## CD Player D730/731 Out-of-Speed Control

Section of Circuit diagram of PCB 1.630.152.20 and later

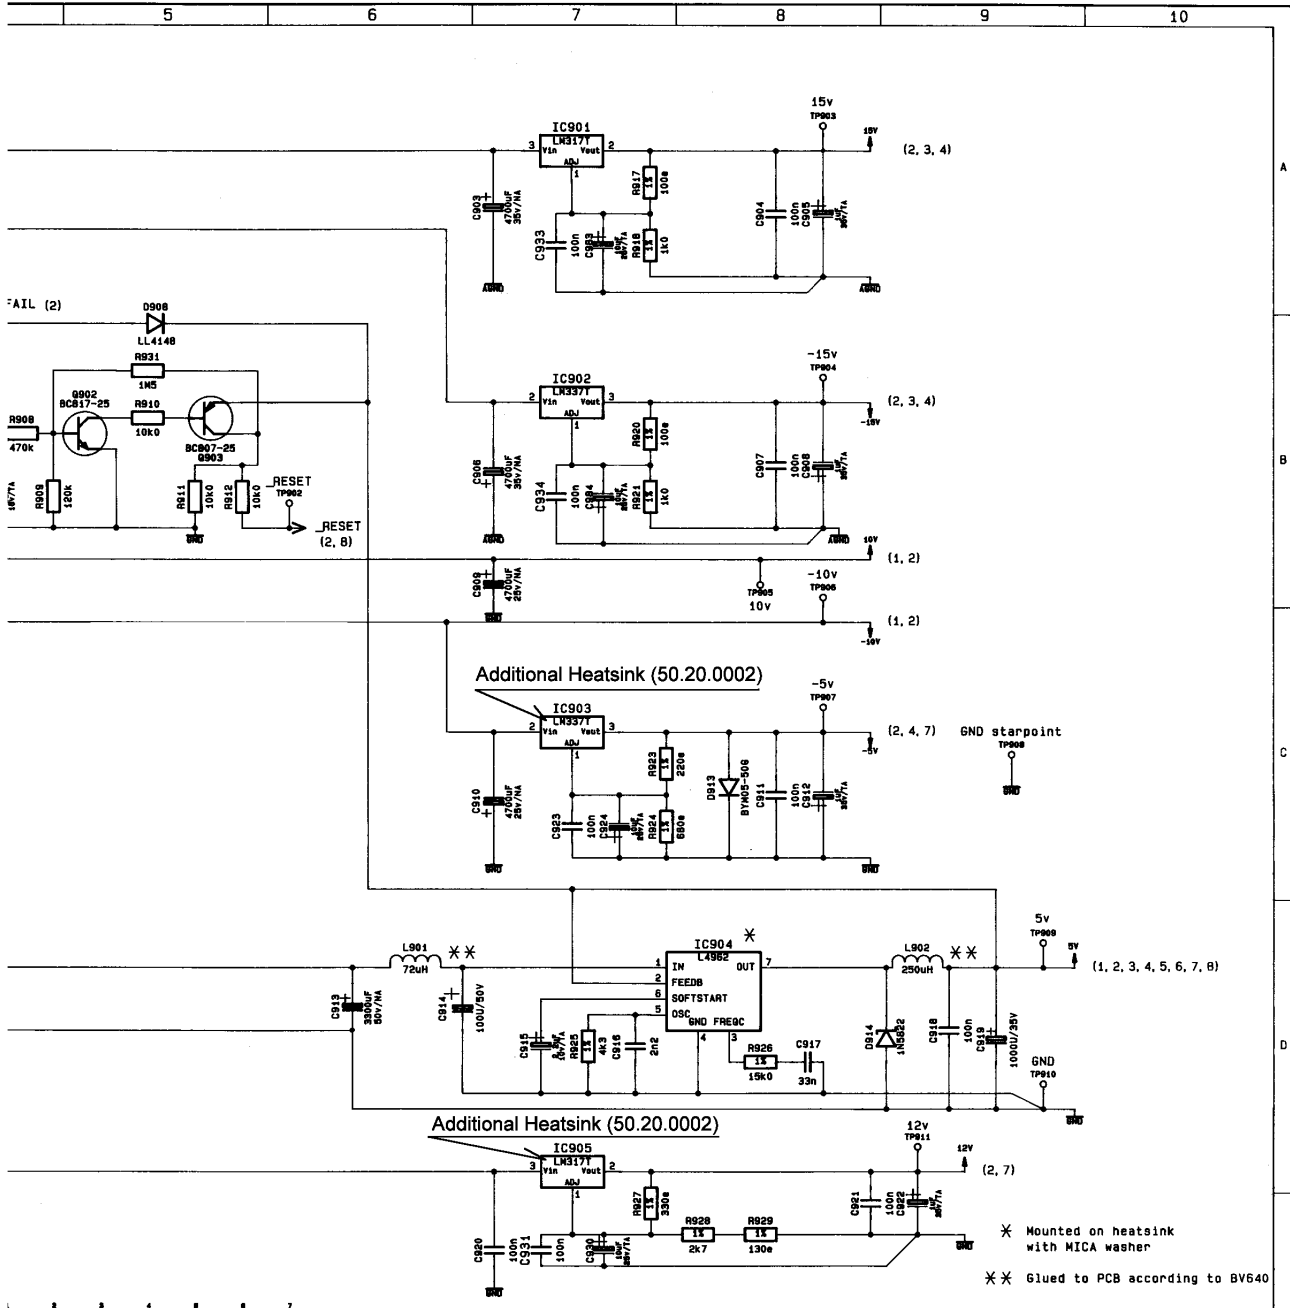
Recently, we finally discovered that the series regulator LM317 (IC 905) increases its output voltage when aging. The series regulator from National Semiconductor is heating up and collapses. The voltage rises up to 12 Volts. Due to this fact, IC703 (HEF4750 on Mainboard 1.630.152.XX) is supplied with excess voltage and is damaged.

The regulator's heat is dissipated by a heat sink, and IC 703 (frequency synthesizer) HEF4560 must be replaced, if having been supplied with excess voltage. At this occasion, we strongly recommend to add an other heat sink to the negative regulator (IC 903), too. By these actions, the chip temperature drops for both regulators.

1. Unsolder the series regulator LM317T (IC 905). Add a heat sink (50.20.0002) to a new LM317T (50.10.0104 - Motorola). Apply thermal compound, if available. Mount the heat sink with an Allen-head screw (21.53.9354) to the LM317. Do not cut the regulator's terminals in order to avoid heat accumulation when mounted.
2. Reinstall the regulator to the PCB, leaving the terminal leads as long as possible. Take care that the heat sink is completely isolated from any component. Bend the regulator's terminals carefully in such a way that the heat sink does not touch C913.
3. Add an other heat sink (50.20.0002) to the LM337T (IC 903), as described above with LM317T. Usually, it is not necessary to replace the regulator LM337T (50.10.0105) by a new device <sup>(1)</sup>, unless it is obviously defective.
4. Replace the defective IC 703 (refer to page 2 - HEF4750V, 50.99.0179)

Spare Part	Studer Order Number	Reference	Count
Heat sink	50.20.0002	to IC903 and IC905	2
Allen-head screw M3x6	21.53.9354	to IC903 and IC905	2
LM 317T Motorola	50.10.0104	IC905	1
LM 337T <sup>(1 refer to item - 3.)</sup>	50.10.0105	IC903	1
HEF4750V	50.99.0179	IC703	1
